**Meeting of the Central Valley Flood Protection Board
March 21, 2008**

**Board Staff Report
West Sacramento Area Flood Control Agency
Application No. 18313**

Board Action

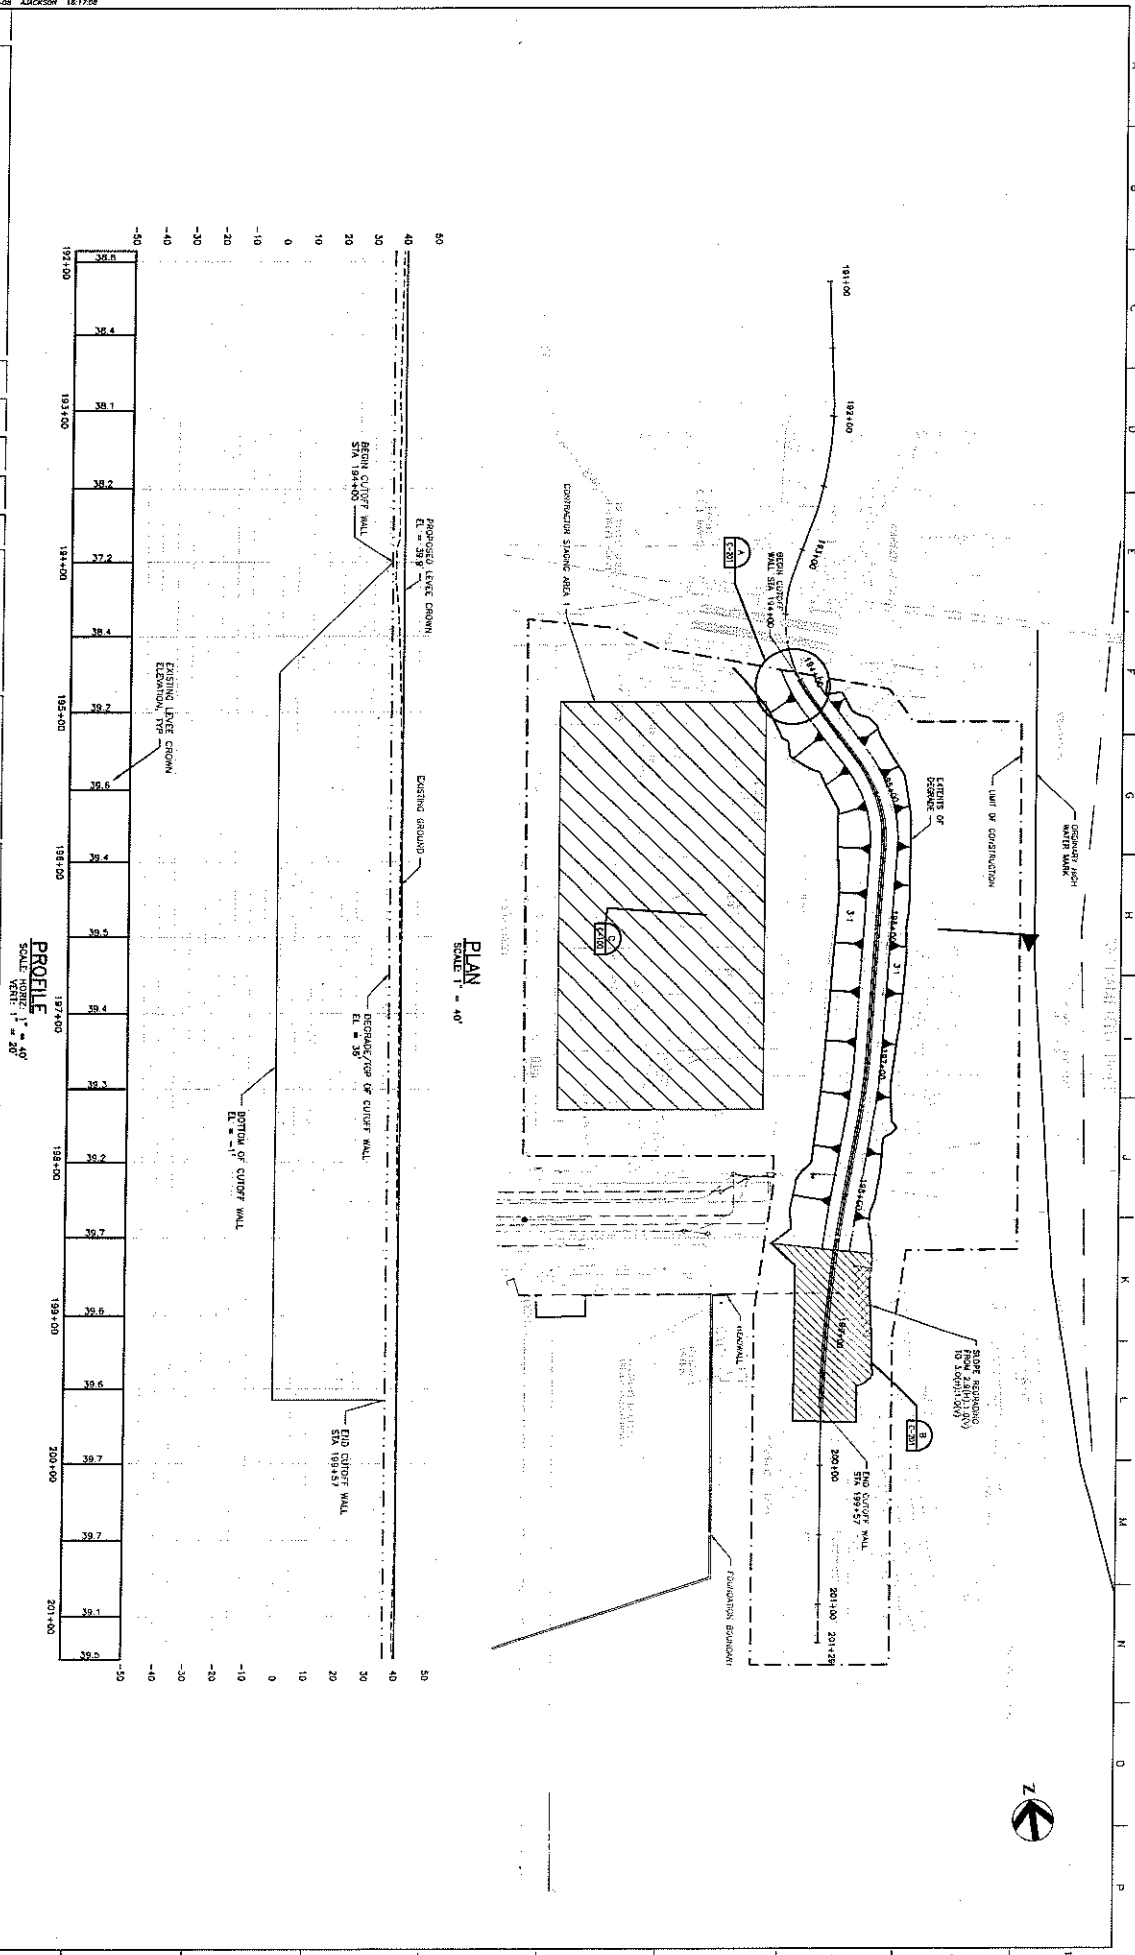
The geotechnical investigation formed the basis of the selection and design of the slurry cutoff wall to mitigate the levee seepage and stability deficiencies. The geotechnical investigation describes the subsurface conditions of the project site based on the field borings drilled at the project location and to the north of I Street Bridge. It found that the levee embankment consists of poorly graded sand to silty sand. Below the levee embankment materials, a five to eight feet layer of sandy silt and lean clay blanket layer was observed. These soils were underlain by silty sand that was approximately 5 to 15 feet thick. The silty sand was underlain by a four to nine-foot layer of sandy silt and lean clay. Below these semipervious layer (blanket) is a 40-ft thick layer of sand, which is underlain by a 25-ft thick layer of gravel (Exhibit 4). Similar subsurface conditions were found to the north of I Street Bridge.

The seepage analyses found that the exit gradients for existing conditions are within the Corps criteria of 0.5, with the highest calculated value of 0.48 on the 200-year + 3 water surface elevations. This exit gradient was reduced to 0.4 after construction of a 40-ft slurry wall. For the other water surface elevations, the exit gradients were well below the 0.5 criteria and basically remain the same with the addition of the 40-ft deep slurry cutoff wall. However, the modeling analysis shows water seeping through the sand levee. With the addition of the slurry cutoff wall extending through the levee, the through levee seepage deficiency is mitigated to an acceptable level.

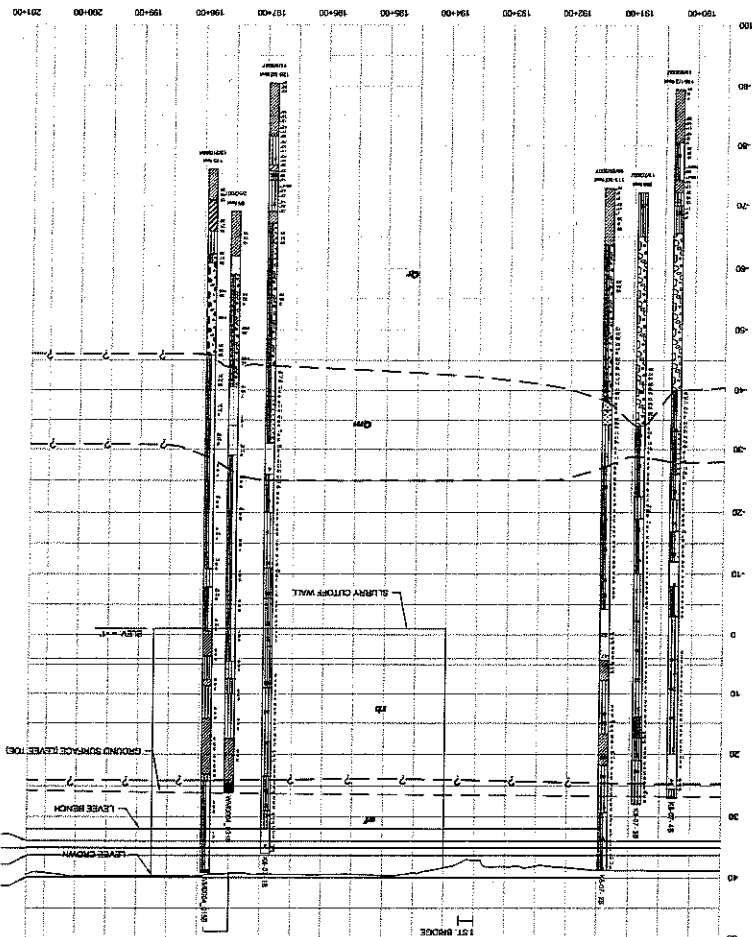
WSAFCA is proposing to construct a 475-ft long and 40-ft deep slurry wall in the west (right) bank levee of the Sacramento River, from the I Street Bridge southward. A 50-ft section of the landward levee slope at the southernmost section of the repaired section would also be flattened to bring the slope to 3 horizontal:1 vertical (See Exhibit 3).

The HDR Administrative Draft Problem Identification Report identified approximately 50 feet of levee section on the southern most part of the project with a slope of 2.5H:1V. WSAFCA proposes to flatten this section to bring the slope to 3H:1V to meet the more stringent Corps criteria.

Staff agrees with the proposed construction of a 40-ft bentonite slurry wall to mitigate for seepage and stability deficiencies. Staff also agrees with the proposed slope flattening to bring a section of the levee to 3H:1V slope.
